May 20, 2026 | Titan Install & Titan Portal for FINCH III | Informational

Resolution: Software Fix Coming - Titan Install & Titan Portal Version 1.3 - June 2, 2026

**Relay Polarity on Titan Install
version 1.2.4**

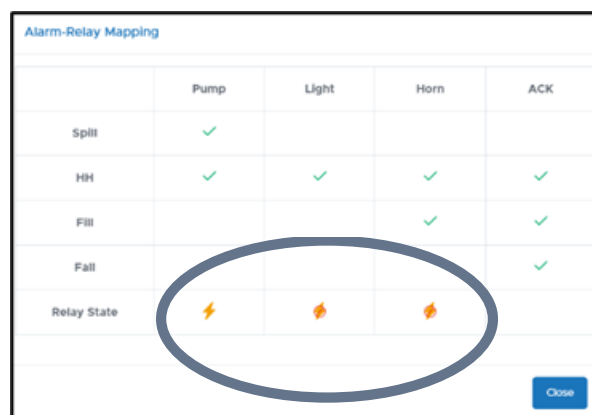
- The relay polarity values shown on the User Interface of Titan Install and Titan Portal (version 1.2.4) are currently shown as reversed.
- "True" and "False" values are displayed *opposite* of their intended state (energize/de-energize).
- This is strictly a user interface issue and does **not** affect actual FINCH III relay functionality during commissioning.

The images above highlights the "energize/de-energize" icons showing the reverse settings

Titan Logix will be correcting the relay polarity icons in our next release of **Titan Install & Titan Portal Version (version 1.3)**.

This update will only fix the User Interface reverse issue and does **not** change FINCH III operation.

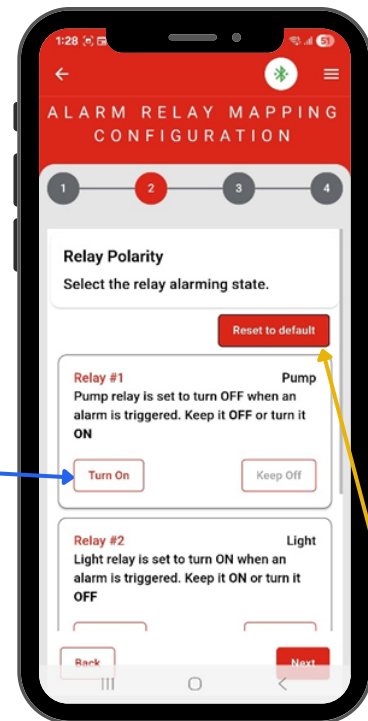
IF YOU **CHANGED** RELAY POLARITY SETTINGS:

Current Workaround: Titan recommends restoring your Relay Polarity settings back to the default settings in Titan Install on any units you updated these values on.

From the **Alarm Relay Mapping** → **Relay Polarity Configuration Screen #2** page, complete the following:

Tap the following icons

- Relay #1 Pump = Turn ON
- Relay #2 Light = Keep OFF
- Relay #3 Horn = Keep OFF

This restores the correct default Relay Polarity FINCH III settings.

Make sure to **NOT** press the **Reset to default** button on this screen. Use the Turn ON and Keep OFF button series from above instead.
